June 17, 2015

To: The City of Schenectady Planning Commission

Re: The Need to Relocate and Significantly Reduce the Size of the Proposed Pylon at the Mohawk Harbor Casino

Illustration 2: Pylon Collage 2 (click for larger version online)

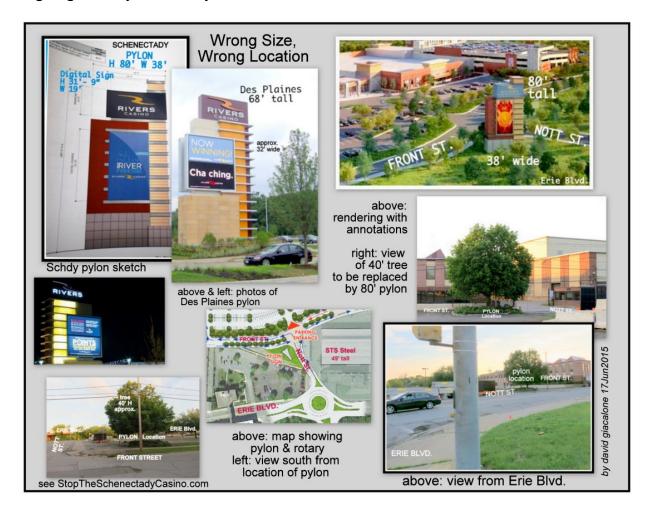
Similarly, and also for safety reasons, the City of Philadelphia allows no digital displays within 200' of an intersection. [Philadelphia Code, §14-904 (1) (b) Digital Display] The Second Illustration (above) shows the

placement of the pylon directly at an intersection crucial to those entering and leaving the Casino, to the retail customers and residents of Mohawk Harbor, and to residents/visitors of the East Stockade and Stockade District. The proposed pylon is also in close proximity to the Nott Street intersection with Erie Boulevard, and the exit and entrance points for the expected traffic rotary at that intersection. Clearly, Rush Street Gaming hopes to use the digital display to catch the attention of and inform many drivers who will be unfamiliar with the short Nott-Front-Erie block and the Mohawk Harbor layout, and who may have little or no experience traversing a traffic rotary. From the perspective of traffic safety, it is difficult to image a worse location for the enormous pylon, with its glare and mixed messages.
